World Heritage List 2017

**The Bauhaus and its sites in Weimar, Dessau and Bernau [extension to Bauhaus and its Sites in Weimar and Dessau, (ii)(iv)(v), 1996] (Germany)**

**WH List 2017\_ "The Bauhaus and its sites in Weimar, Dessau and Bernau [extension to Bauhaus and its Sites in Weimar and Dessau, (ii)(iv)(v), 1996]"\_Interim Report Additional Request**

## **(VII) ADGB Trade Union School, Bernau**

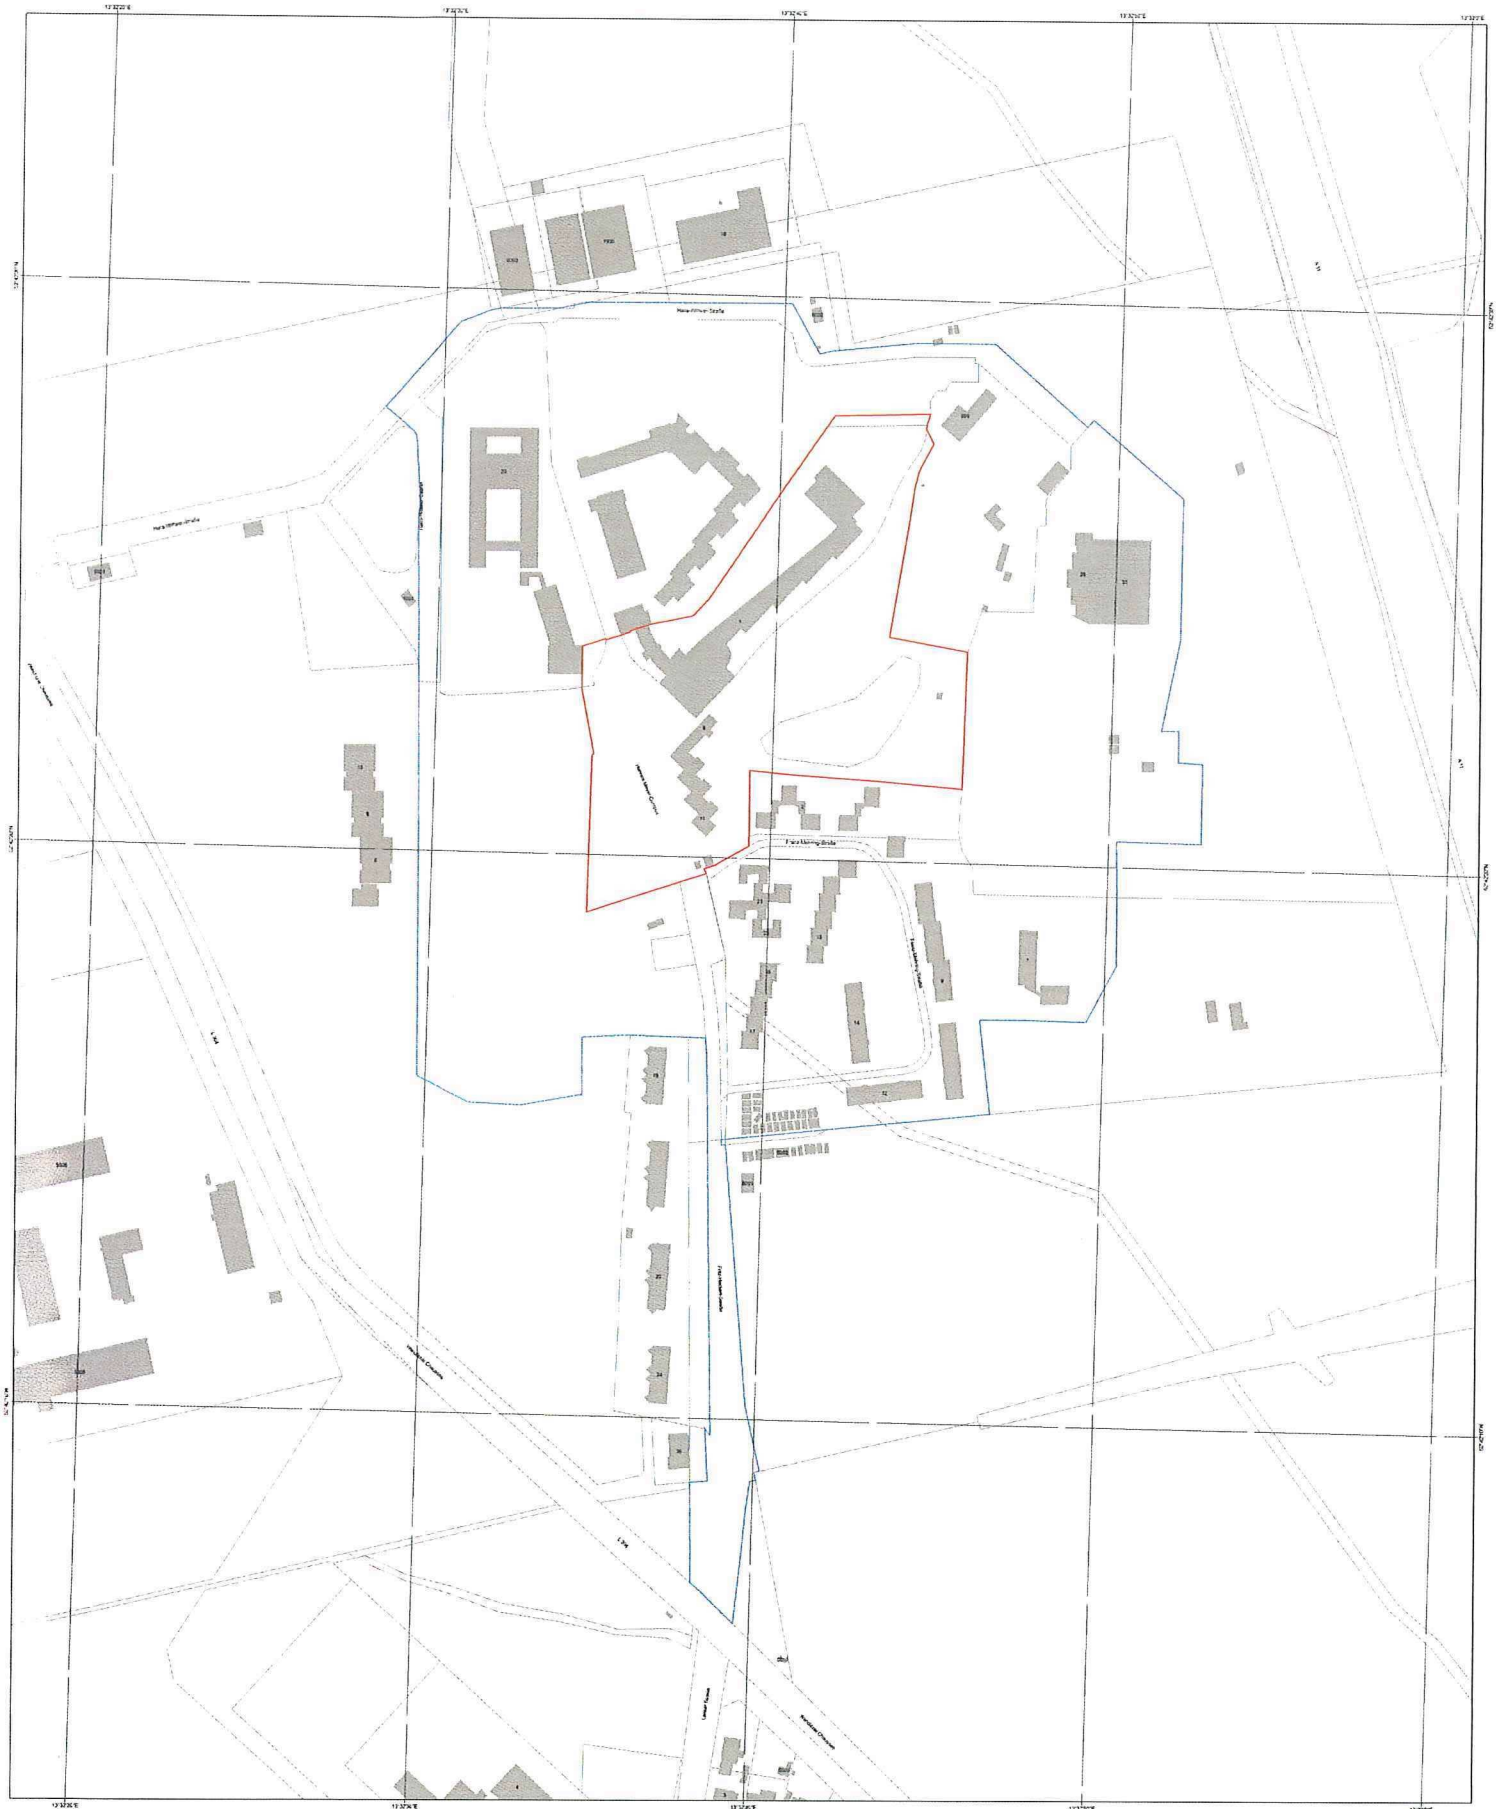
*Could the State party consider changes in the boundaries of the nominated area in the ADGB Trade Union School in order to include some of the open space surrounding the buildings that initially belonged to the land, which was part of the Bauhaus project?*

In accordance with the proposal of the ICOMOS Panel to complete the nominated area of the ADGB Trade Union School by including existing appertaining outdoor facilities, we have amended the nominated area for this component as follows (cf. application, layout plan fig. 22, fig. 62, fig. 67 and master plan, p. 168/169). It now includes:

1. the driveway roundabout (design by Hannes Meyer) in front of the building complex consisting of the school and the boarding home,
2. the historic western forest edge of the area along the driveway up to the level of the transformer building,
3. the rear outdoor area located to the south and east of the teachers' residential buildings and the school and boarding home complex, including the terrain levels included in Meyer's plan and the ground water pond surrounded by trees,
4. the free spaces to the east and north of the building structures and
5. the free space located between the school and boarding home complex as well as the north-western expansion buildings (which do not form part of the complex) from the 1950s, including the pergola with the terrace behind the entrance segment.

In effect we confidently propose the following changes to the nominated property of component (VII):
